## **IMPORTANT SAFETY RECALL 20V-103**

# SAFETY NOTICE

# SN681A

SUBJECT: Leveling Sensor Installation

Figure 1 – Level Sensor Location on End Mount Machine

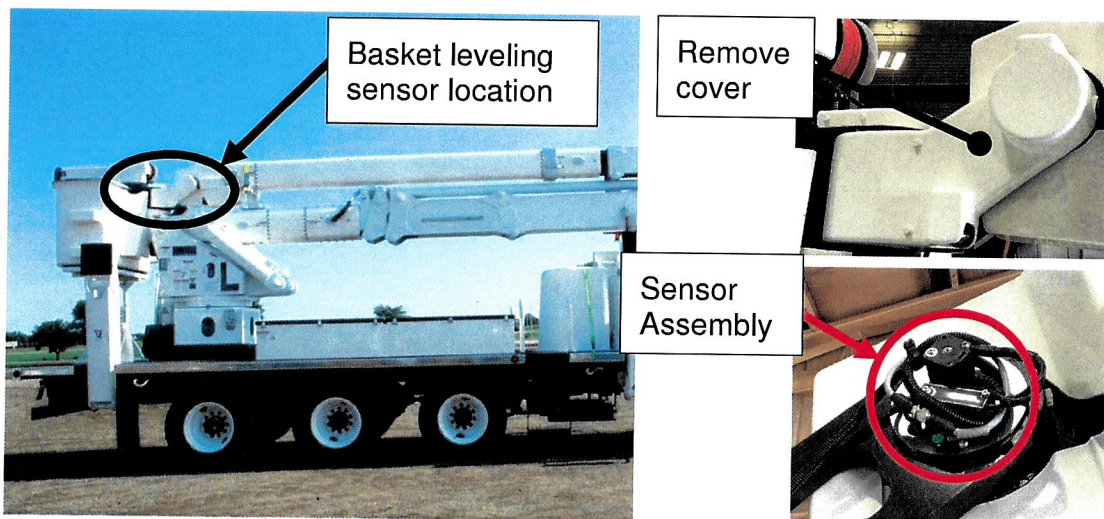
On Terex TM aerial devices, manufactured from February 2011 through April 2020, the basket level limit sensors at the boom tip may have been assembled in the incorrect orientation. The limit sensors prevent the platform from going more than 15 degrees from level if the electrical system malfunctions or there is damage to components. The incorrect mounting of the level sensors may cause an out of level basket to continue moving more than 15 degrees out of level. **If the leveling system malfunctions it may cause the occupants to fall from the platform.**

**Figure 3A**  
This bulletin applies if the light colored potting visible on the top sensor, or sensor labeled A on the bottom

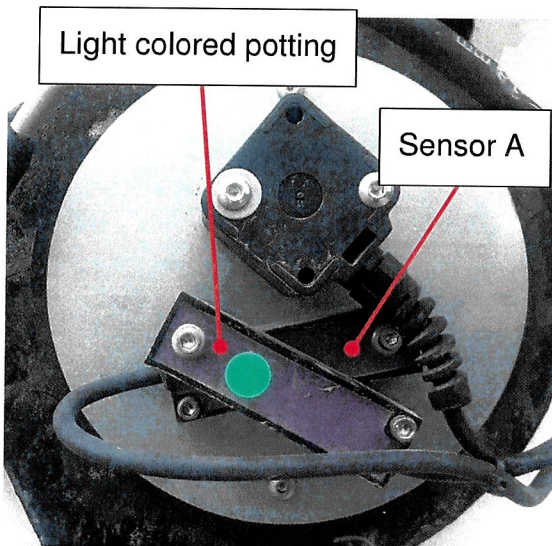
3. If your unit has the light colored potting visible on the top sensor, or the sensor labeled A on the bottom; this bulletin applies. Correct following the instructions in Field Service Kit Z1562. Take a picture before correcting the issue and another picture after correcting the issue. Send both pictures with the completion form including the serial number and date of correction to [utilities.warranty@terex.com](mailto:utilities.warranty@terex.com).
4. If your unit has the light colored potting visible only on the bottom sensor with the wires coming out of the sensors above the mounting screw and with sensor labeled A on top this bulletin does not apply and use can continue without restriction.

The unit noted above had the leveling sensors incorrectly mounted as shown in either Fig. 3A or 4A of the SN681A bulletin. The sensor position has been corrected by following the instructions provided in Field Service Kit Z1562.

**Figure 4A**

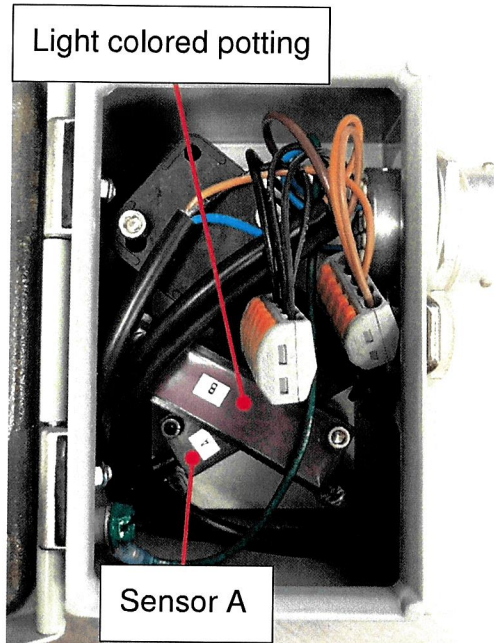
This bulletin applies if the light colored potting visible on the top sensor, or sensor labeled A on the bottom

**Figure 4B**

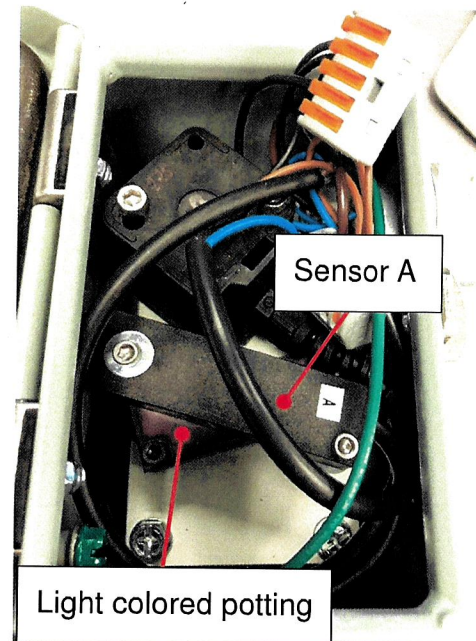
This bulletin does **NOT** apply if the light colored potting only visible on bottom sensor and sensor labeled A on top

The leveling sensors have been inspected on this unit and are positioned correctly when compared with either Fig. 3B or 4B on the Safety Notice 681A bulletin and **no repair is required**. Please submit a photo of the mounted sensors with this completion form. **\*No reimbursement for only completing this inspection.\***
